BULLETIN T-64-41

SUBJECT: TRIUMPH TR-4 WINDOW  
WINDER REGULATOR

DATE: DECEMBER 10, 1964

A-A

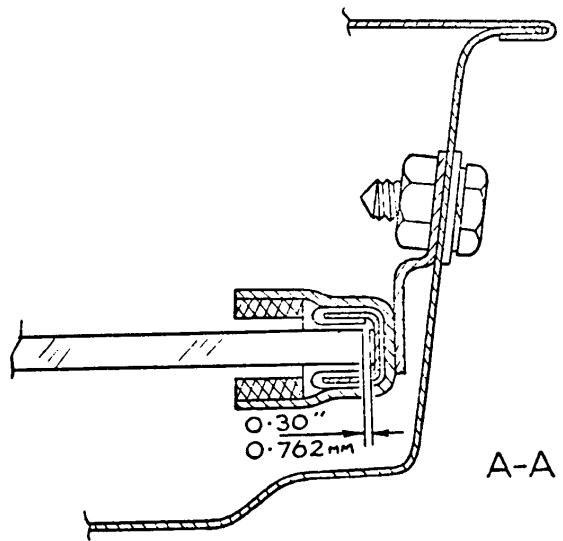
1. Remove trim panel.
2. Raise window and check the clearance of the glass fore and aft in the top of the rear channel. The recommended clearance is .030" which should be maintained for the whole length of the channel. Excess clearance will allow tilting and the jamming of the glass and insufficient clearance will produce stiff operation. Clearance can be obtained by the use of packing washers between the inner door panel and top channel bracket (see illustration A-A).

B-B

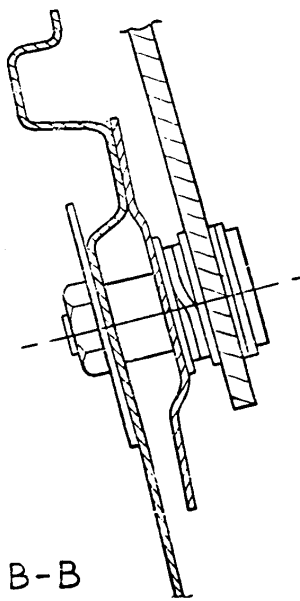
3. Adjust bottom brackets and crimp the tie rod to ensure that the channels are parallel (illustration C).
4. Remove regulator pivot pin nut and delete spring washer under head of nut. Add washer WP0119 1/2"x 7/8" x .050" behind head of pivot bolt and additional washer WP0160 5/16" x 1 5/8" x 16 S.W.G. behind head of nut (illustration B-B).

5. Tighten nut sufficiently to allow ease of operation and peen or center pop end of thread.
6. Refit trim.
